**Plan Commission Meeting – October 9, 2024
Agenda Item 3**

PLAN COMMISSION REPORT AND RECOMMENDATION

**Plan Commission Meeting – October 9, 2024
Agenda Item 4**

STAFF REPORT AND RECOMMENDATION
Saunders Place Subdivision – Tentative Plat
Current Address – 275 Saunders Road

SAUNDERS PLACE
 TENTATIVE PLAT
 FOR
AMERICAN INDUSTRIAL HEAT TRANSFER
 CITY OF LAKE FOREST, LAKE COUNTY, ILLINOIS

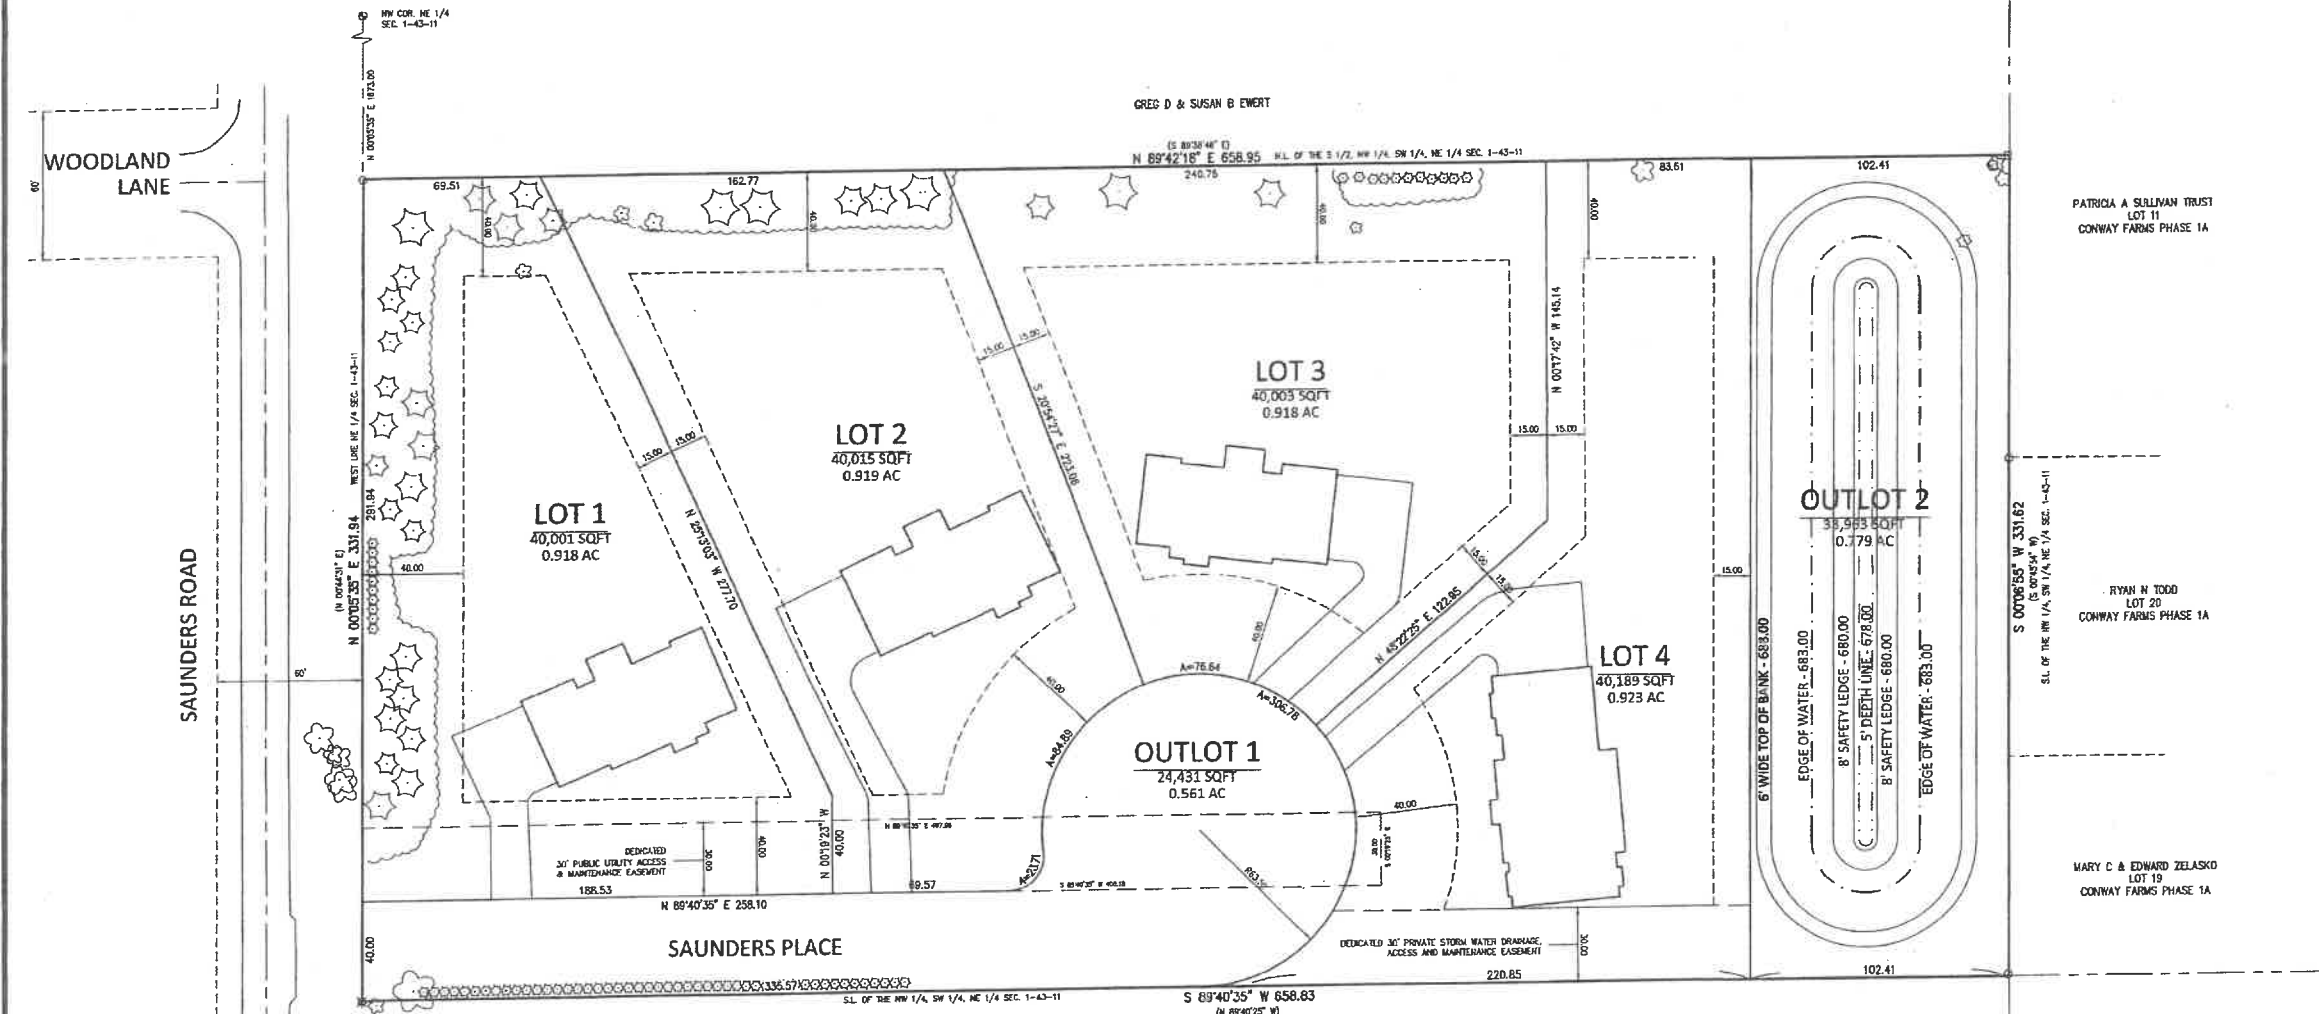
The rear yard setback from the east property line of Lot 4, the property line shared with the retention pond outlot, is reflected on the tentative plat as 15 feet rather than 40 feet. The width of the adjacent Outlot is 102 feet which provides a significant setback from the homes in Conway

Technically, the north property line of Lot 4 is considered a side yard so a 15 foot setback could be applied however, given the long narrow configuration of the lot, the principal structure, the residence, is not likely to be located in that area so the distinction may be moot. The setback for accessory structures such as pool houses, detached garages, and sheds in the R-3 District is 10 feet from the rear property line and 15 feet from the side property lines.

- Outlot 1 is the private road and cul-de-sac. Private roads are permitted to serve up to four buildable lots. The name of the road as noted on the tentative plat will need to be reconsidered to avoid confusion with the existing road in this area, Saunders Road. Distinct street names are required by the City in new subdivisions to minimize confusion and to expedite public safety response.
- Outlot 2 is located along the east property line extending the full width of the property and will serve as a retention pond for the subdivision. The pond will accept stormwater through the stormwater easement located along the south edge of Lot 4. The pond is intended to hold water and will not be a dry bottom detention area. The pond edges are proposed to be planted to provide an amenity to the subdivision.

Sidewalks do not appear to be reflected on the preliminary plans. The City does not require sidewalks along private roads however, as ownership changes, the City often receives requests for sidewalks from residents. The petitioner is encouraged to consider adding a sidewalk to one side of the private road. The sidewalk would be the responsibility of the Homeowners' Association.

The City Code does not permit gated subdivisions. A gate at the entrance to the private road is reflected on the preliminary plans. Gates are permitted at driveway entrances to individual properties.

- a. The square footage of the buildable areas on each lot in addition to the overall lot size.
 - b. A note shall be included on the plat stating that the Homeowners' Association is responsible for all ongoing maintenance of the Outlots including maintenance of the detention pond, all components of the on site stormwater management system such as swales and pipes, and the private road and cul-de-sac.

- c. A note shall be included on the plat stating that all of the new homes shall be equipped with residential sprinkler systems for fire protection as required by Code.

- d. A note shall be included on the plat stating that no future subdivision of Outlot 2 is permitted.
